PETITION FOR ZONING RE-CLASSIFICATION SPECIAL EXCEPTION AND/OR VARIANCE

BALTIMORE COUNTY ZONING PLANS ADVISORY COMMITTEE

RE: Item No. 10 (Cycle 1 - April-October, 1981)
Petitioner - Charles W. Held et ux
Reclassification Petition

Re: Item #10 (Cycle I - April-October 1981)
Property Owner: Charles Held
196' S. on the S/S Greenridge Rd. 641' E. of York Rd.
Existing Zoning: D.R. 5.5
Proposed Zoning: D.R. 16
Acres: 2.07 District: 9th

PLAT TO ACCOMPANY PETITION FOR
RECLASSIFICATION FROM
DR 5.5 ZONE TO DR 16 ZONE

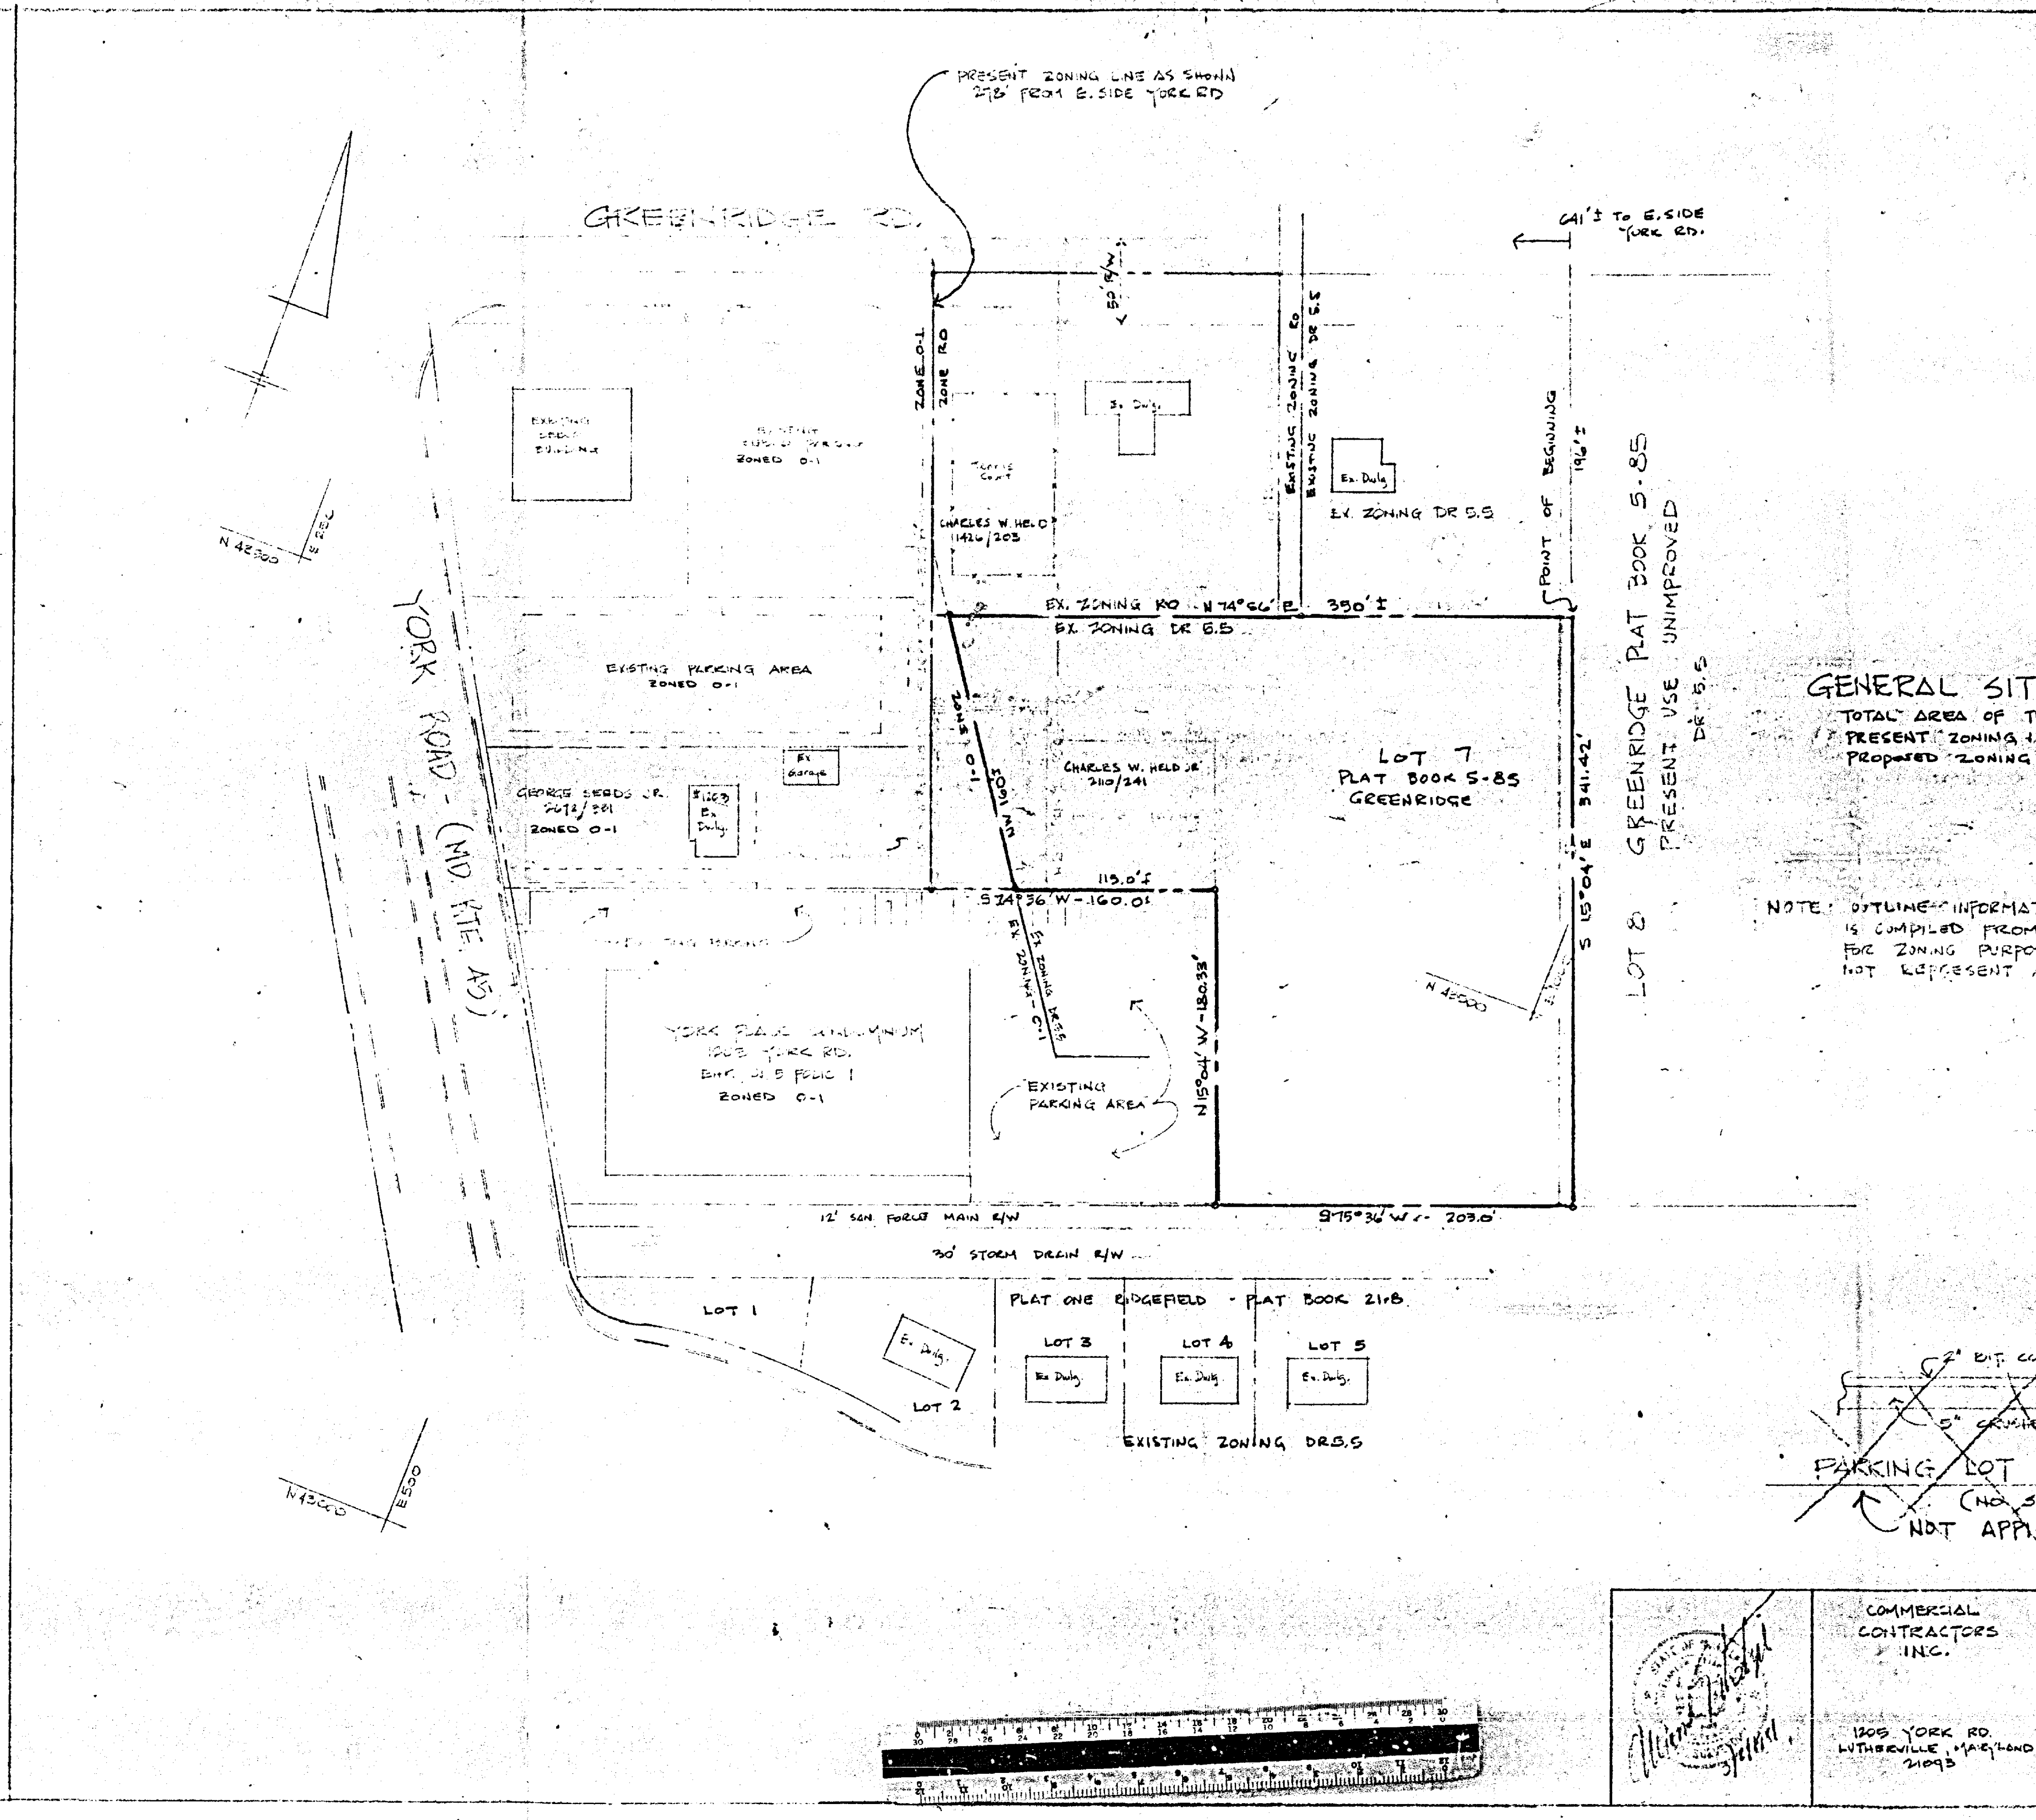
A review of the brief submitted with this request indicates that the proposed use of this property will be for parking. As stated in our previous conversation, either the site plan must be revised to comply with Bill 46-79 or the brief must be changed.

Greenridge Road, an existing public road, is proposed to be further improved in the future as a 36-foot closed section roadway on a 50-foot right-of-way (See Drawing #70-0494, File 5). Highway right-of-way widening, including any necessary reversible easements for slopes, will be required in connection with any grading or building permit application.

Provisions for accommodating storm water or drainage have not been indicated on the submitted plan.

The submitted plan does not indicate the 20-foot drainage and utility easement within the 1205 York Road site nor the 24-inch storm drain and the existing and future 8-inch public sanitary sewerage therein. Further, the future 20-foot drainage and utility easement, centered 5 feet westerly of the westernmost side property line of the Petitioner's property, and the future extension of the public 24-inch drain and 8-inch sanitary sewerage therein are not shown on the submitted plan, see Drawings #74-0810, File 1 and #74-0811, File 4.
